Reviewer Report for the S2 Time-Domain Pulsar Search

**LSC Meeting
May 5, 2004**

Checks of Results

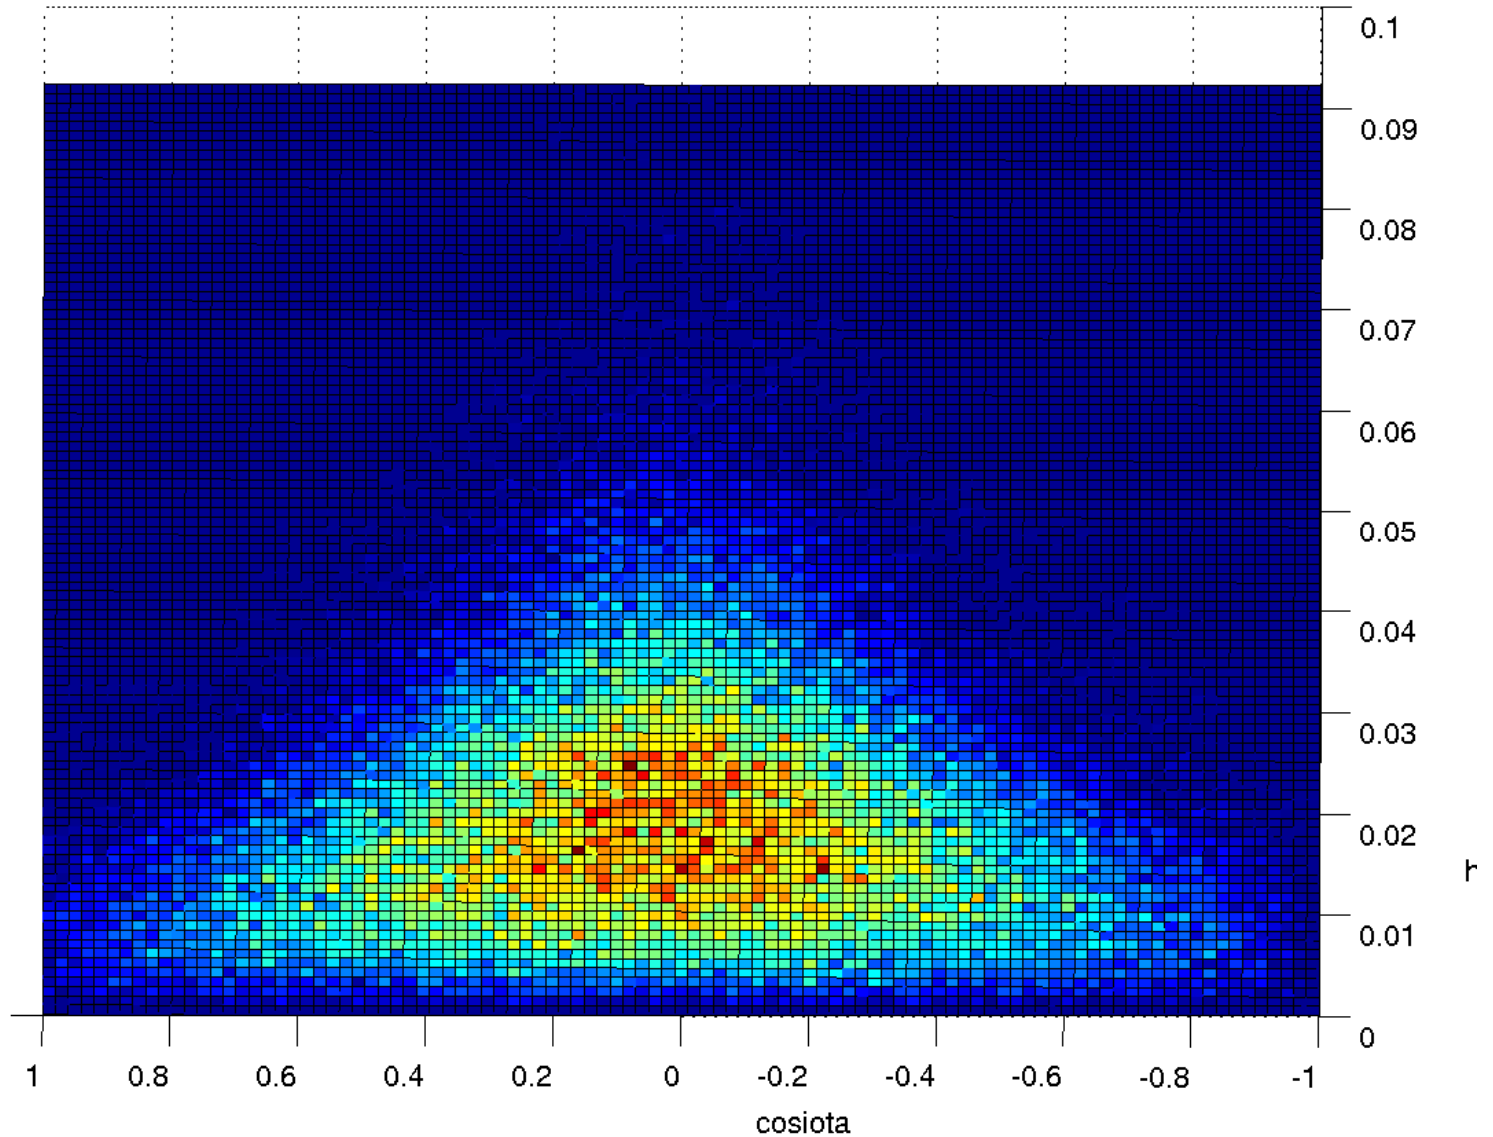
Examined posterior pdf distributions and numerical limits

Sanity checks

Consistency check

Understand why $\cos(\iota)$ is usually peaked near zero

Due to marginalisation with correlated parameters

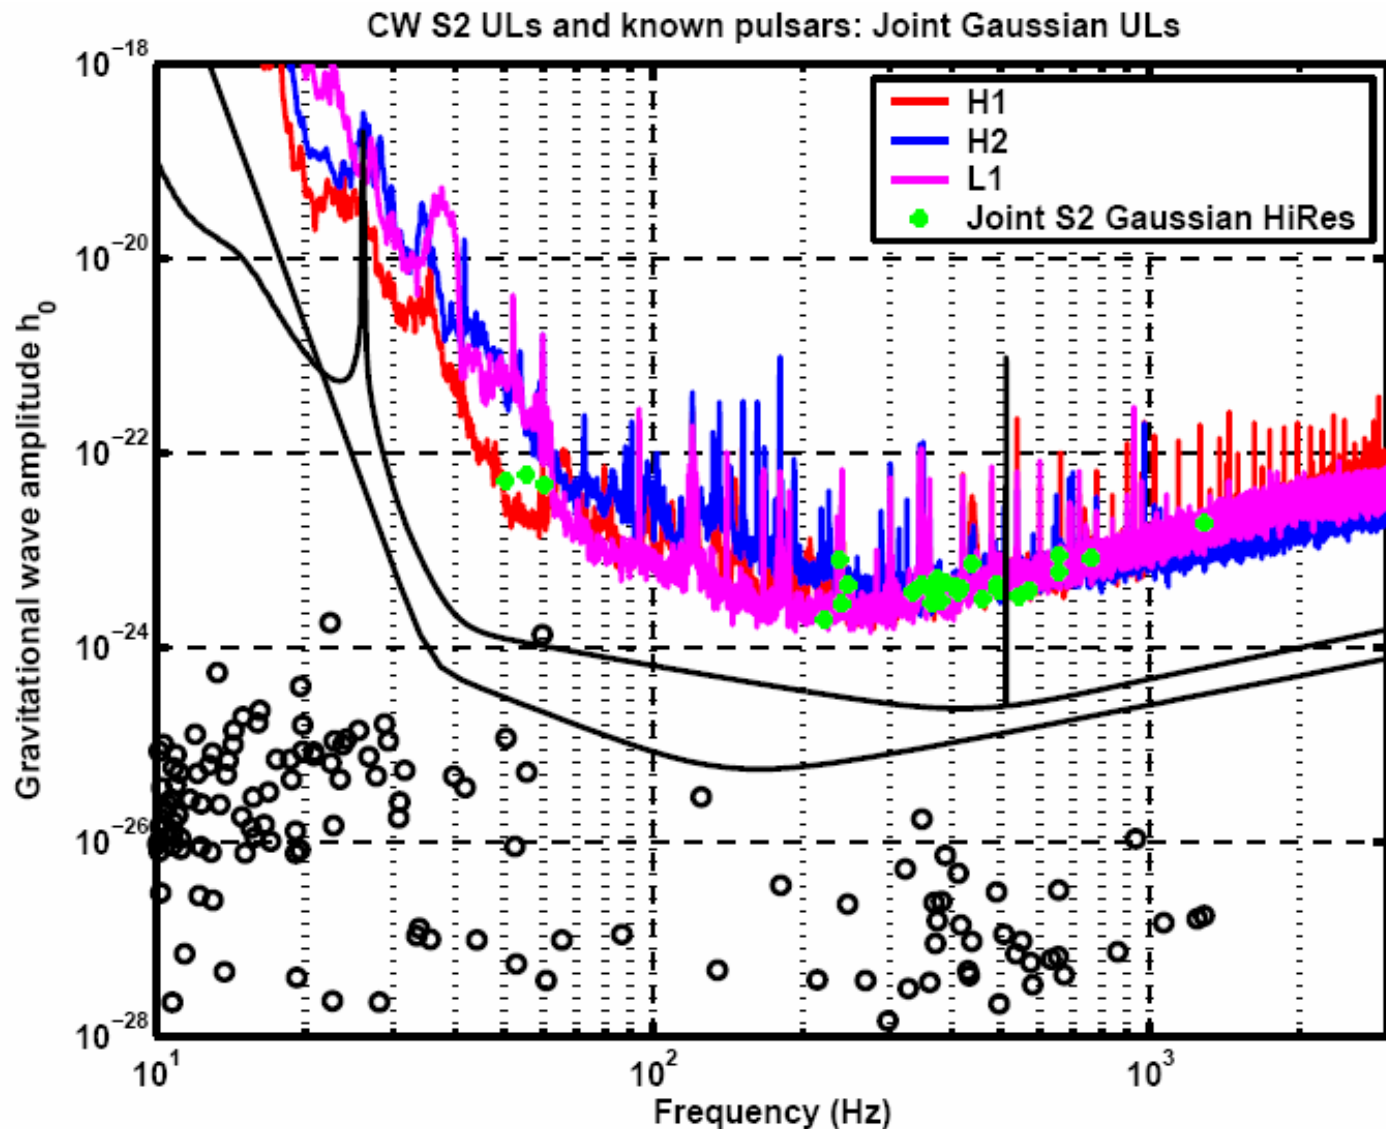
Checked calculated upper limits against expectations

Given noise curves
